Paper No. 6443

Some contributions from nuclear power to engineering practice†

Ian Davidson, M.Eng., M.I.C.E.*Discussion*

FIG. 3.

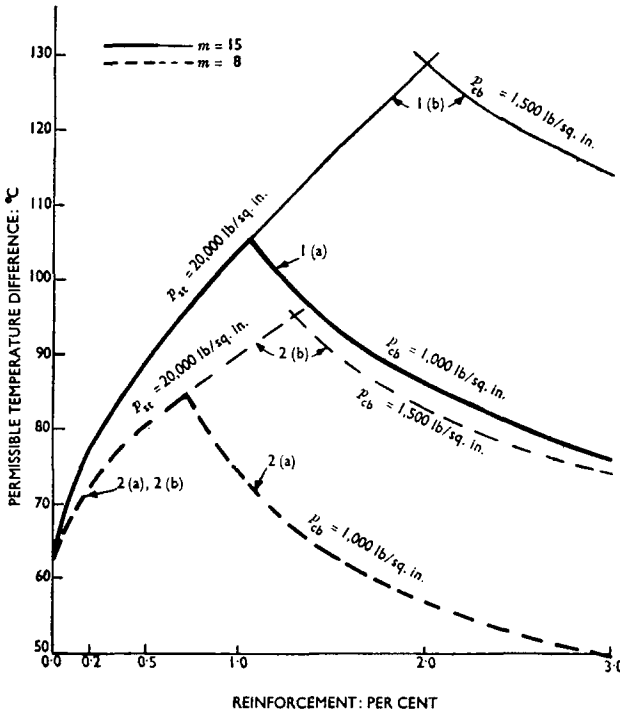
The permissible temperature difference varied with reinforcement percentage according to curves 1(a) and 1(b) in Fig. 3. However, with high-grade concrete, or for a rapidly established temperature gradient, it might be appropriate to employ a lower value for m . Curves 2(a) and 2(b) showed the lower permissible temperature differences if $m=8$. It was interesting to note that resistance to temperature gradient was improved by increasing reinforcement up to the "economic percentage", but thereafter diminished.

130. Assuming that concrete was uncracked by tensile stress up to a limit of 500 lb/sq. in., corresponding curves 3 and 4 could be plotted as shown in Fig. 4. This might be supposed to give a truer picture. On this basis, resistance to temperature gradient was only slightly improved by adding reinforcement, within the usual range of percentages. Even assuming no reinforcement, some 70–80°C temperature difference appeared to be acceptable, the criterion then being a degree of cracking corresponding to fully stressed reinforcement at the cooler face.

183. Mr Severn had drawn attention to the importance of the assumptions made in a theoretical treatment of the effect of thermal gradients in concrete. Fig. 1 had been included in the Paper to provide a lead-in to the subsequent discussion of the concrete pressure vessel. It was accepted that such an analysis was really over-simplified.

FIG. 4.

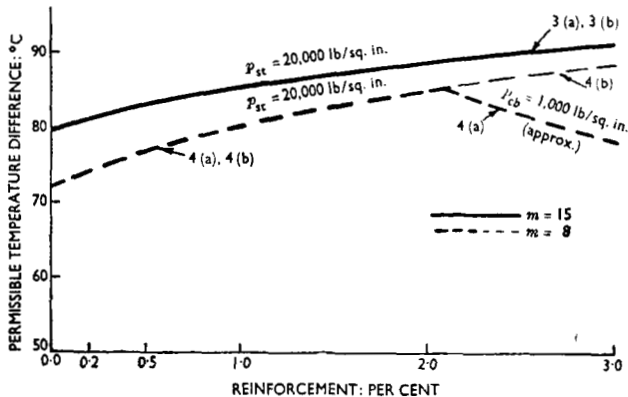
133. In order to examine this behaviour over a longer period, beams 10 ft long by 10 in. deep by 6 in. wide were tested in identical pairs. One such beam was subjected

FIG. 6.—BEAMS MADE OF GRAVEL CONCRETE: LONG-TERM DEFLECTIONS

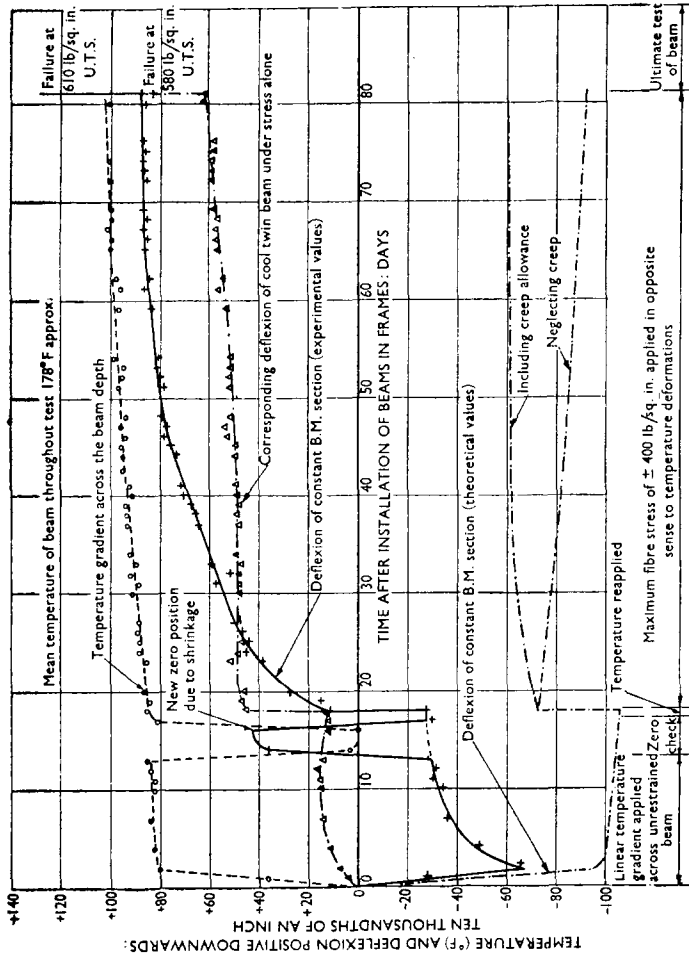
134. The deformation characteristics of a typical pair of unreinforced beams of gravel aggregate concrete were shown in Fig. 6, together with a theoretical prediction based on simple bending theory and on concrete characteristics as determined by standard tests.

135. The difference between the actual deformation and the predicted values was most pronounced and was thought to arise from several contributing factors, all of which required much more experimental verification:—

- (a) The modulus of the heated beam, determined in flexure, was found to be considerably below that of the unheated control beam.
- (b) The heated beam displayed considerably greater creep than that at ambient temperature.
- (c) Perhaps most important of all, differential shrinkage substantially reduced the deformation due to temperature. It was of interest to note that the maintenance of a constant electrical heat input throughout the tests led to a steadily increasing value of temperature drop through the beam, as shrinkage reduced the conductivity of the concrete.

184. Other evidence that the effect of thermal gradients required the most careful study had been provided by Mr Hannah's valuable contribution. The striking result of moisture migration, produced by temperature, in reversing the expected deflexion of test beams showed that this effect must be taken into account, although there was at present much uncertainty about the rate at which moisture content would change in the considerable thicknesses under consideration.

FIG. 7.—EFFECT OF TEMPERATURE ON RELAXATION OF STRESS IN DIFFERENT MAKES OF 0.2-IN.-DIA. WIRE STRESSED INITIALLY TO 70% OF ITS TENSILE STRENGTH

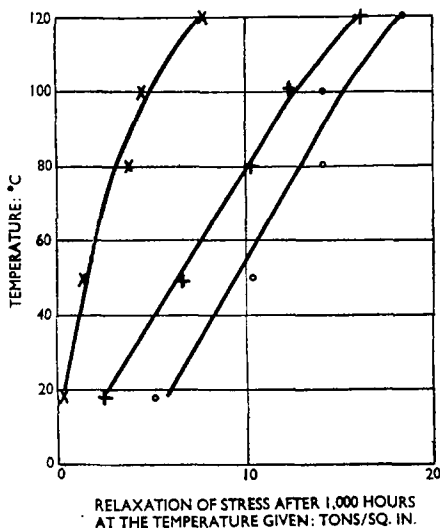
140. Preliminary tests in connexion with the irradiation tests showed that the effect of temperature alone on the relaxation of stress in hard-drawn steel wire was somewhat greater than had been expected. An investigation of this effect was therefore started to determine its importance for wires of 12 S.W.G. and 0.2 in. dia. of British manufacture. Stressing rigs similar to those designed for the irradiation tests were being used for the tests, which were being made at temperatures between 18 and 120°C. Since the testing procedure for the examination of the effect of temperature was simpler than for that relating to irradiation, some results showing the influence of temperature on relaxation were available. A selection of these results for several different wires of 0.2 in. dia. was shown in Fig. 7, where the losses of stress given were those recorded from 1 min after stressing, over a period of 168 hours (7 days) at 18°C, followed by a period of 1,000 hours at the temperature given.

141. While the test period was short in comparison with the service life of a pressure vessel, the results showed that the increase in relaxation of stress with temperature was substantial. At temperatures slightly above normal it would be necessary to make an increased allowance for loss of prestress in design, which at higher temperatures, i.e. 100°C, might well be prohibitive for some makes of wire. It seemed likely, therefore, that the positioning of tendons in prestressed concrete pressure vessels would be largely conditioned by the effects of temperature in the surrounding concrete.

185. The work on the behaviour of hard-drawn steel wires under irradiation and under moderate temperatures, which Dr Bate had reported, would provide information vital to the concrete pressure vessel concept. Tribute should be paid to those responsible at the Building Research Station for successfully developing the necessary apparatus to measure the stress in the wires, even after they had been irradiated, and when they could not therefore be handled directly. It should be added that the tests on the effects of temperature, of which some results to 1,000 hours had been given, would be extended to at least 10,000 hours.

FIG. 5.—EXPERIMENTAL RIG FOR INVESTIGATING THE DEFORMATION CHARACTERISTICS OF CONCRETE BEAMS

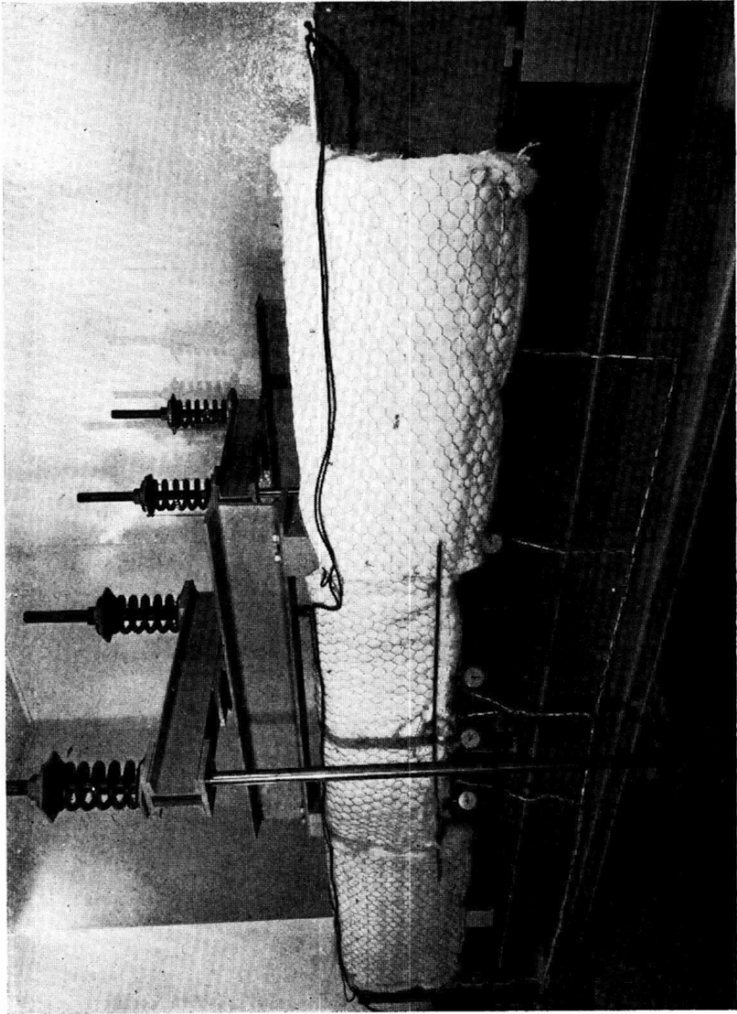
to a constant heat input on the upper face and the deformation due to the gradient established was recorded. After the deformation pattern had been established, both beams were simultaneously equally loaded to a predetermined maximum fibre stress and maintained in that condition for 2-3 months. Again, the deformation characteristics of both the heated beam and the control beam were recorded to indicate the relative creep values. The experimental rig was shown in Fig. 5, facing p. 192.
